Access Compliance Report

Public Rights-of-Way

Intersection ID: 21992	Main Street: WESTINGHOUSE_BV	Cross Street: S_TRYON_ST	Location: NW
ADA ID: 1213C7CD213D	Ramp Type: Perp	Initial Pass/Fail: Fail	Overall Compliance: No
Severity Score: 22.5			
Codes/Mitigation Info/Possible Solution		Field Measurements/Component Compliance

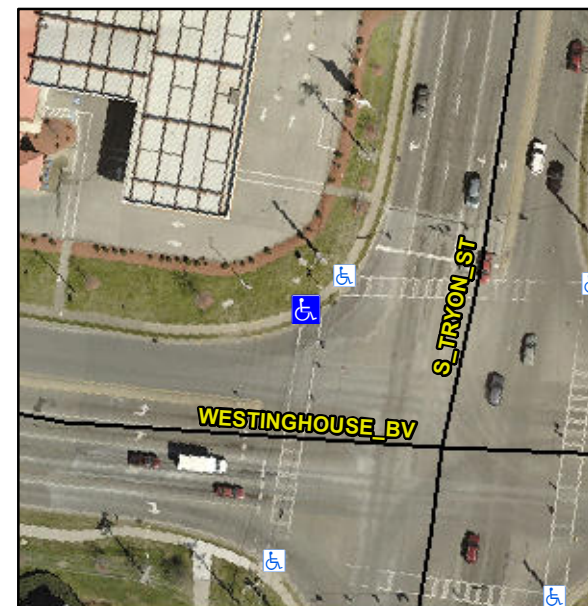
R304.5.1, R304.2.2

Compliance	Description	Data	Compliance	Description	Data
N/A	Ramp Length (in)	89.0	No	Ramp Slope (%)	9.1
No	Ramp Width (in)	44.0	Yes	Ramp XSlope (%)	2.2
N/A	Flare Type LT	N/A	N/A	Flare Type RT	N/A
N/A	Flare Slope LT (%)	N/A	N/A	Flare Slope RT (%)	N/A
N/A	Flare Traversable LT?	N/A	N/A	Flare Traversable RT?	N/A
N/A	Landing Length (in)	N/A	N/A	DWS Provided?	N/A
N/A	Landing Width (in)	N/A	N/A	DWS Contrast?	N/A
N/A	Landing Slope (%)	N/A	N/A	DWS Length (in)	N/A
N/A	Landing X Slope (%)	N/A	N/A	DWS Full Width?	N/A
N/A	Landing Curb? (Y/N)	N/A	N/A	DWS Offset (in)	N/A
N/A	Shared Landing?	N/A			
N/A	Gutter Ponding?	N/A	N/A	Gutter Slope (%)	N/A
N/A	Gutter Lip Ht (in)	N/A	N/A	Gutter X Slope (%)	N/A
N/A	Painted X Walk1?	Yes	N/A	Painted X Walk2?	N/A
	X Walk 1 Direction	To S		X Walk 2 Direction	N/A
N/A	X Walk 1 Width (in)	116.0	N/A	X Walk 2 Width (in)	N/A
	X Walk 1 Slope (%)	0.8		X Walk 2 Slope (%)	N/A
	X Walk 1 X Slope (%)	2.3		X Walk 2 X Slope (%)	N/A

Remove & Replace Entire Ramp.
